# **NVM Express® Technical Proposal (TP)**

Technical Proposal ID 6034	
Revision Date	2024.01.03
Builds on Specification(s)	NVM Express Management Interface Specification, Revision 1.2c  NVM Express Base Specification, Revision 2.0c
References	TP6021 Status Reporting Enhancements TP6027b Reset Behavior Clarifications

This TP adds support for multiple Management Endpoints per port which allows multiple Management Controllers to manage an NVMe Subsystem via NVMe-MI for high-availability use cases.

Figure 4: NVM Subsystem with Dual Ported PCIe Ports and an SMBus/I2C Port

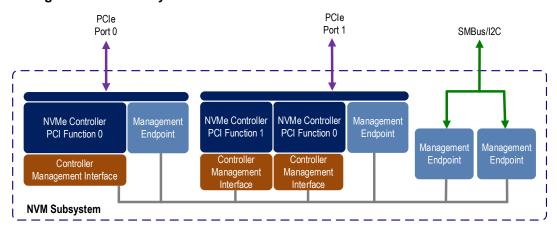
<Note to editor: Update "Figure 4: NVM Subsystem with Dual-Ported PCIe Ports with SMBus/I2C Port" to add a second Management Endpoint on SMBus/I2C:>

Figure 6: Dual-Port PCIe SSD with SMBus/I2C

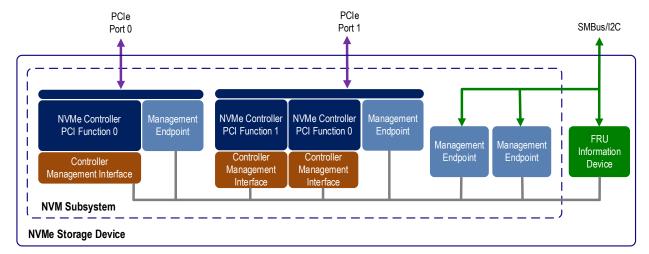
<Note to editor: Update "Figure 6: Dual-Port PCIe SSD with SMBus/I2C" to add a second Management Endpoint on SMBus/I2C as follows:>
